**Tuesday, November 8, 2022
Virtual Platform
57 East 1st Street
4:30 PM**

- 3a DRB22-00784 - District 6.** Within the 9200 to 9300 blocks of East Cadence Parkway (north side). Located south of Ray Road and east of Ellsworth Road. (4± acres). Design review for a commercial development. Ellie Brundige, Gammage & Burnham, Applicant; PPGN-ELLSWORTH, Owner.

3b DRB22-00920 - District 6. Within the 6900 block of East Southern Avenue south side). Located east of Power Road on the south side of Southern Avenue. (1+ acres). Design Review for a restaurant with drive-thru. Greg Hitchens, Applicant; Winco Foods LLC, Owner.

Building Elevations

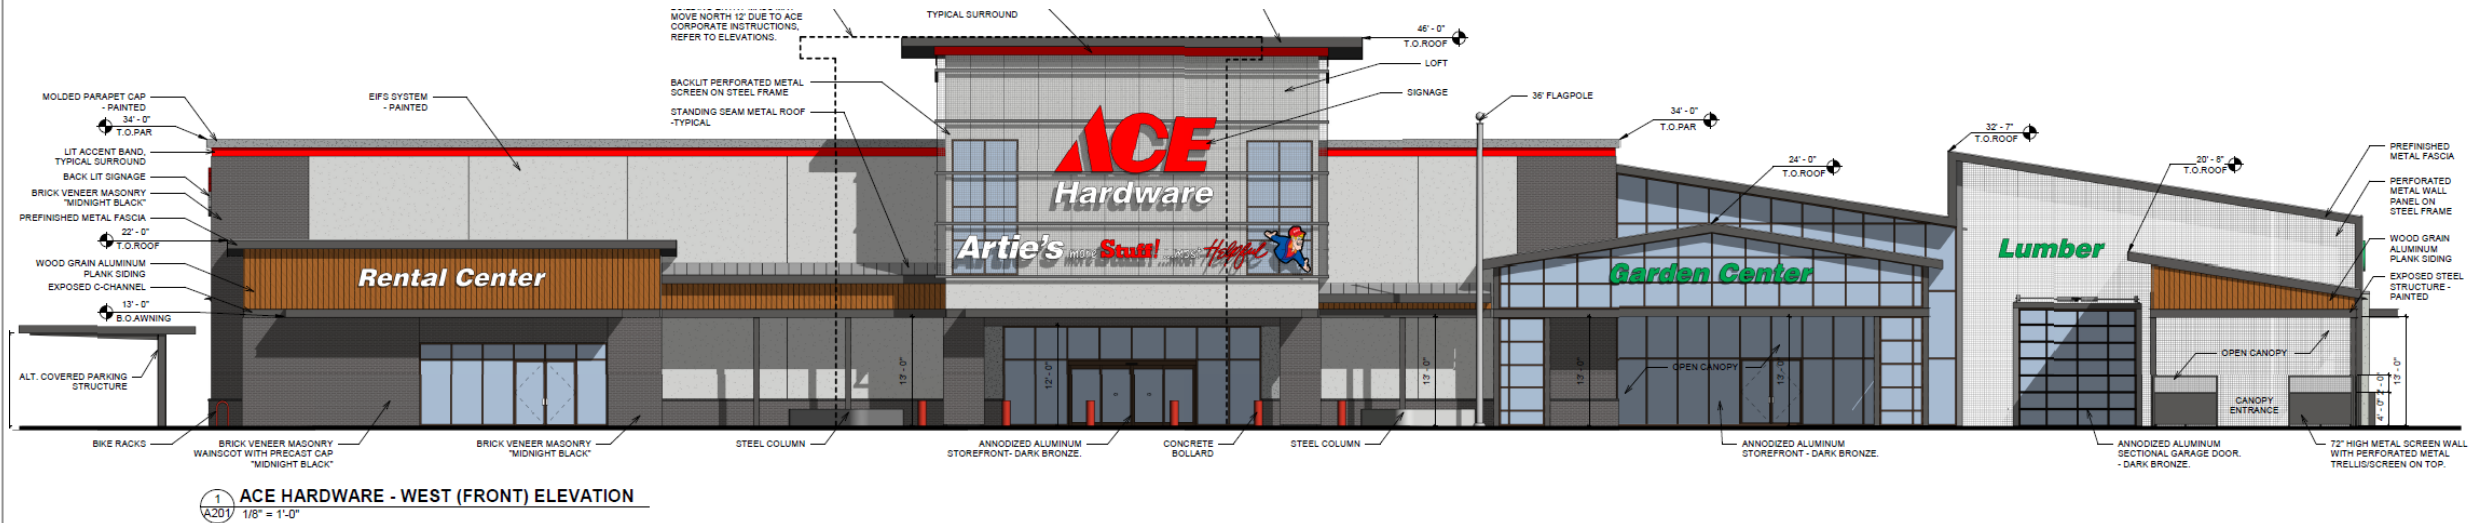
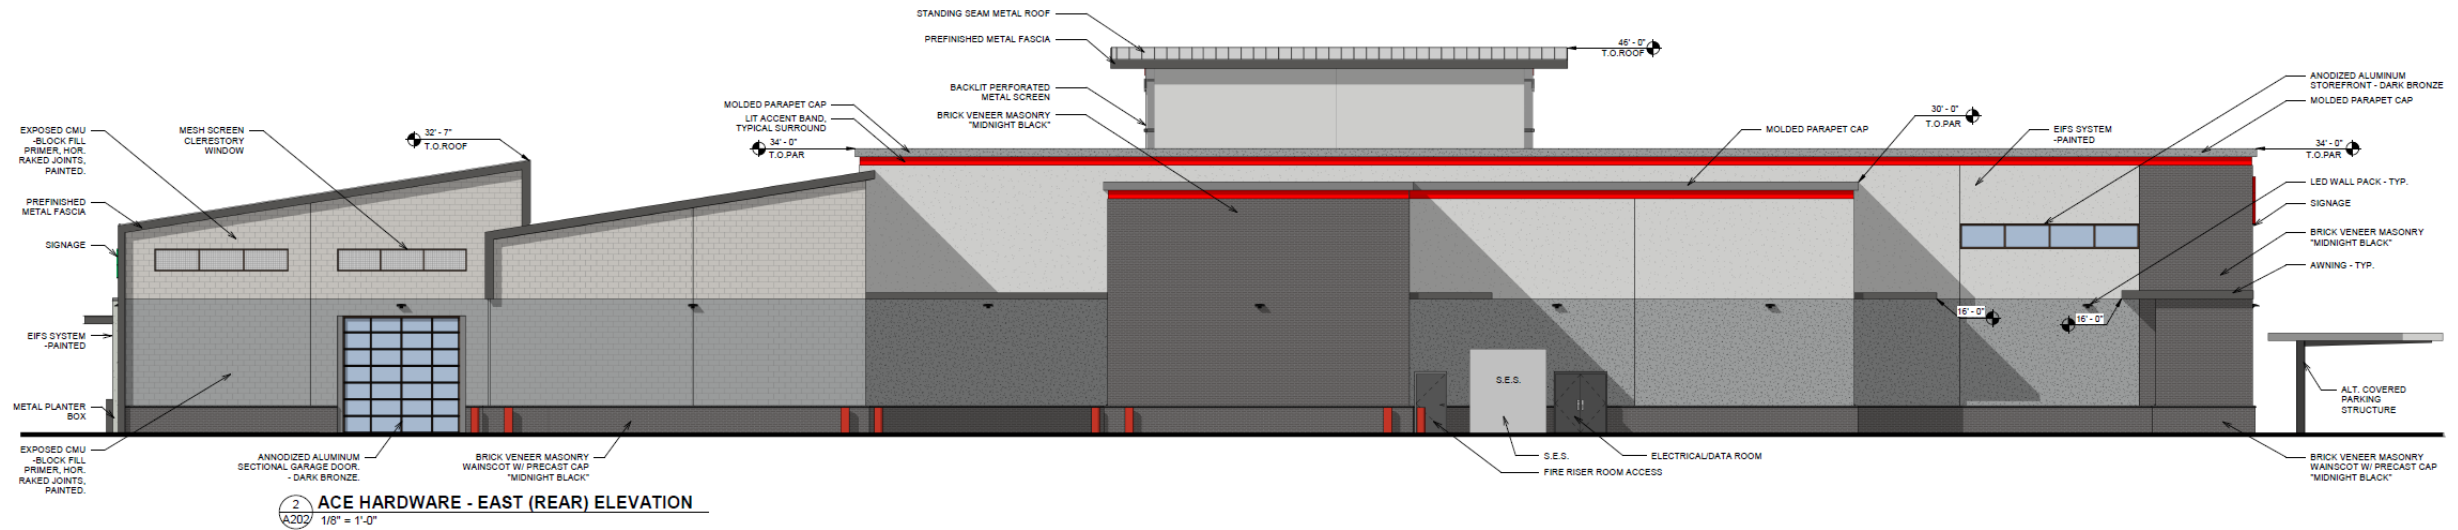
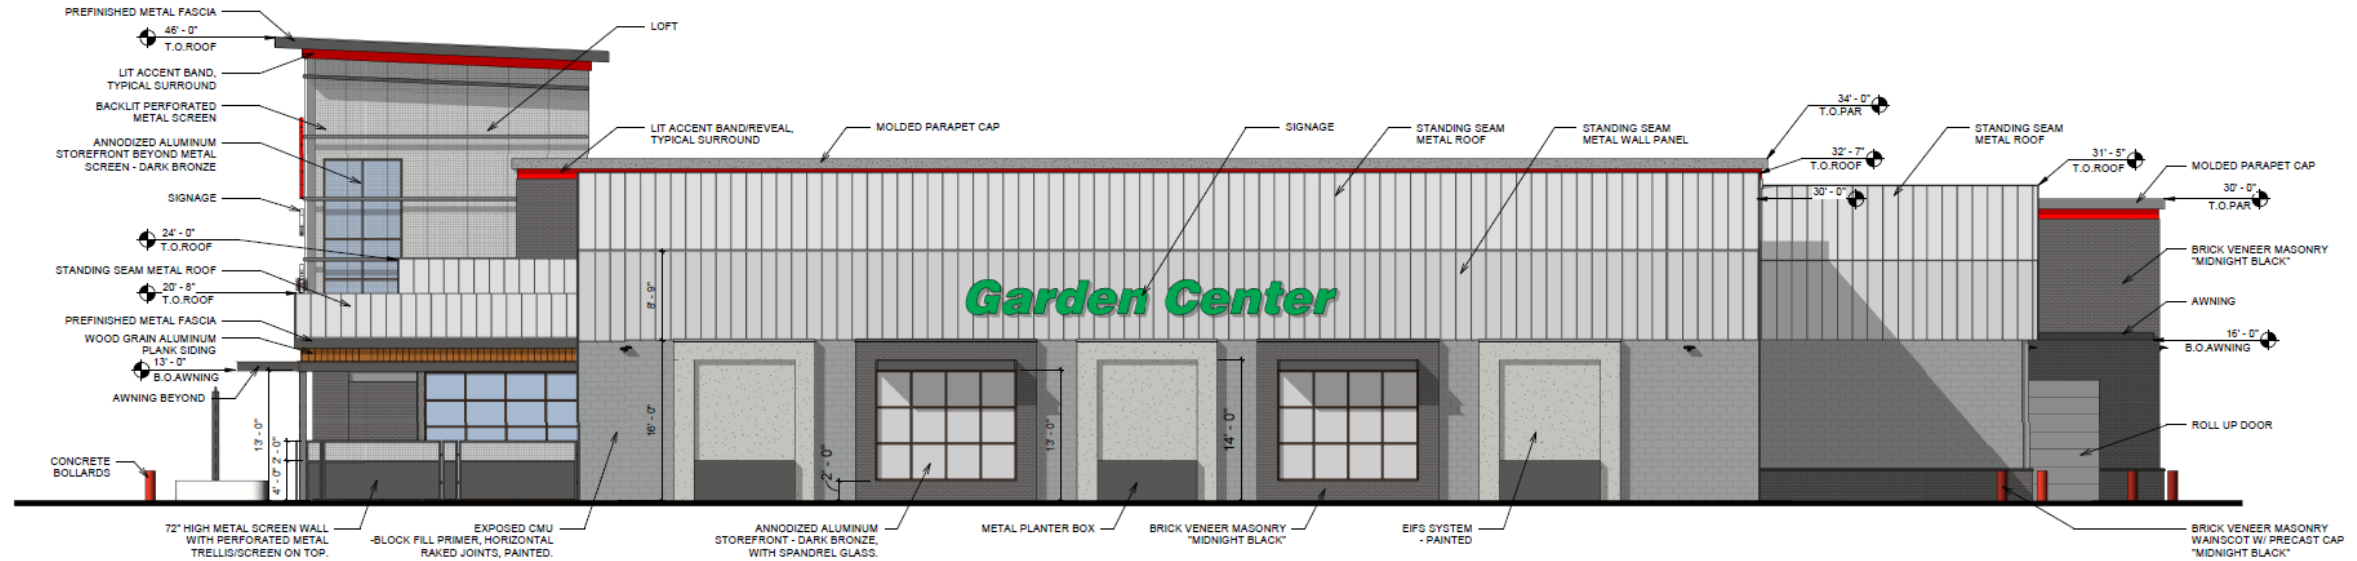
Chair Johnson commented that it is a really great project with interesting building forms and material combinations. He asked for more articulation on the north façade of the building adjacent to Ray Road.

Boardmember Astle agreed with Chair Johnson's concern about the north façade.

- Construction docs should follow this level of design
- Project should have canopy elevations
- Concern over 16' wall at rear of building – possibly different color to hide?
- Appreciated the proposed nighttime lighting for the store
- Project includes “place making” which is good

Applicant Dennis Newcombe added that there is a patio and landscaping on the north façade. He stated that the architecture and the outdoor area will invigorate that area and creates a sense of arrival and interest.

North Elevation

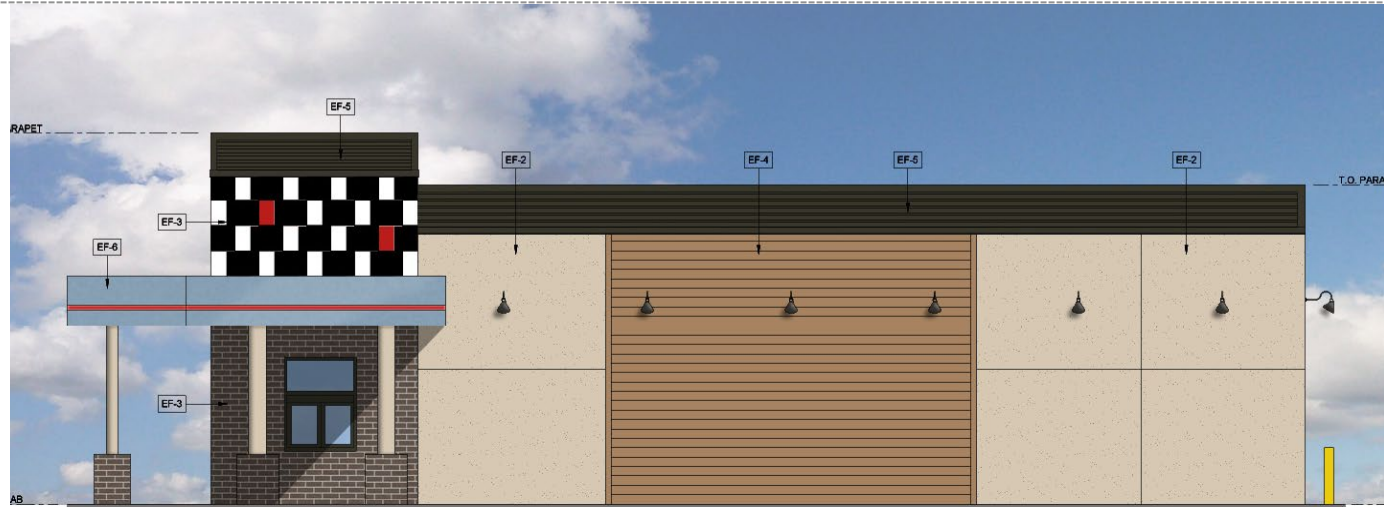
Chair Johnson stated his preference for rectangular columns. He asked for clarification on color of the door on the front elevation.

Chair Johnson added that he preferred the door color to be the same as the mullions.

- No concerns with alternative compliance
- Change of color of the electrical panel located south of the proposed building to match the exterior color of building.
- Change of color of entrance door at the north elevation of the building to match exterior color of building.
- Distinguishing between pedestrian walkways that cross drive aisles by raising the walkway above the drive aisle.
- Relocation of trees close to trash enclosure at the southwest portion of the site.

Applicant Greg Hitchens confirmed the color of the door shown was correct. He added that he was willing to change the door color.
